# LONDON BOROUGH OF ENFIELD

## PLANNING COMMITTEE

**Ref:** 14/04027/HOU

**LOCATION:** 27 Private Road, Enfield, EN1 2EH,

Ref: HO - 07/1  
Hoopers Architects  
15 Priory Lane, Epsfield  
Market Harborough  
LE10 1JH

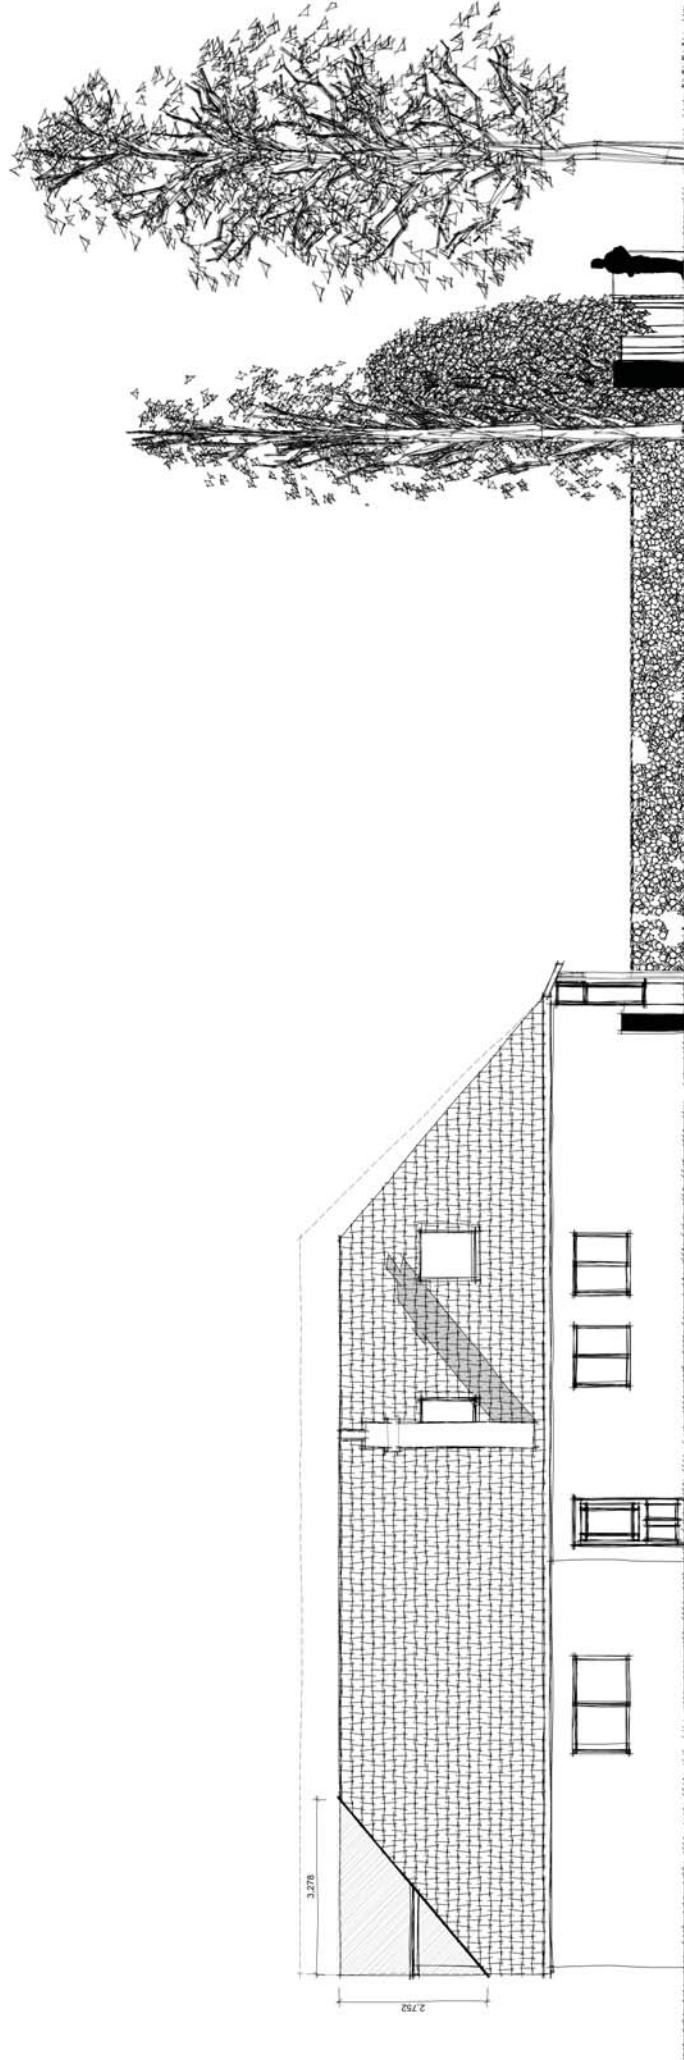
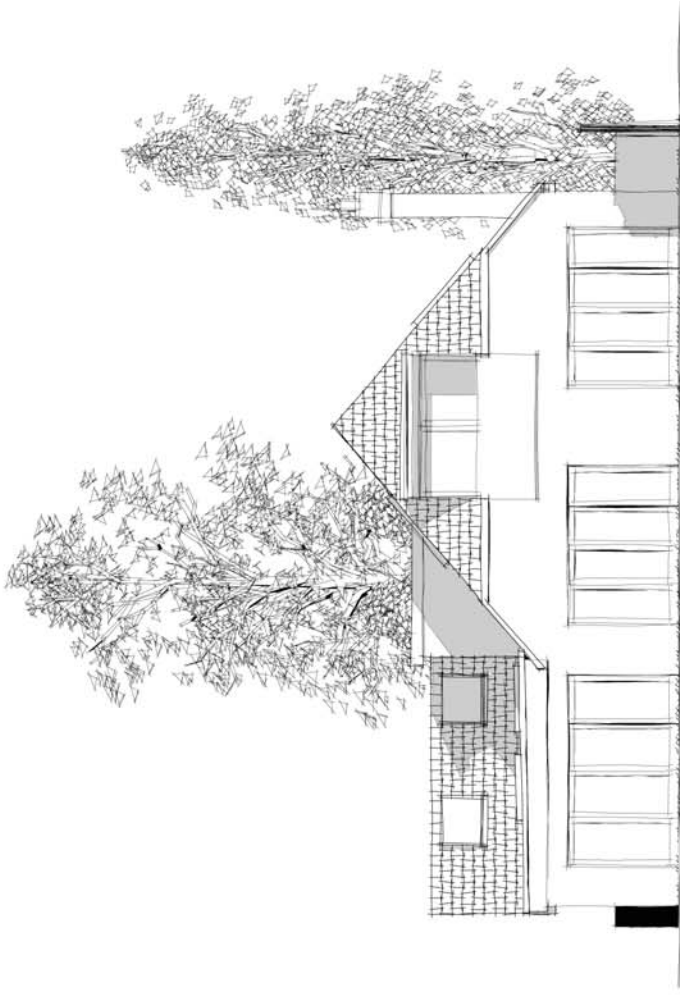
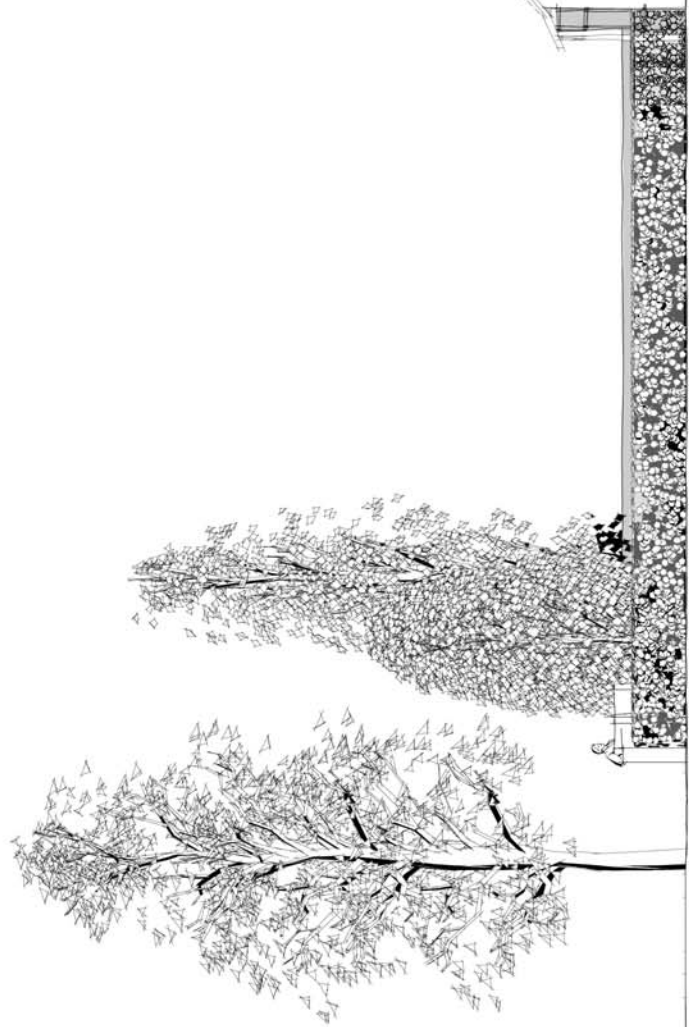
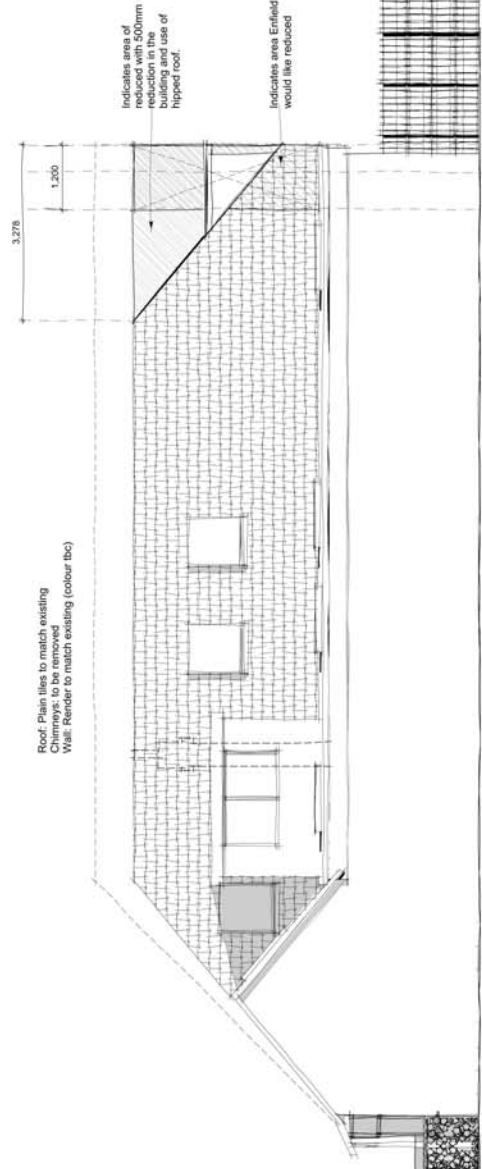
2.4 There is a discrepancy between the proposed side elevations (drawing no. 07/1 and 07/02) and the perspective of the proposed rear elevation (no drawing reference). The rear dormer should have a flat roof to match the side dormer; not a pitched roof.
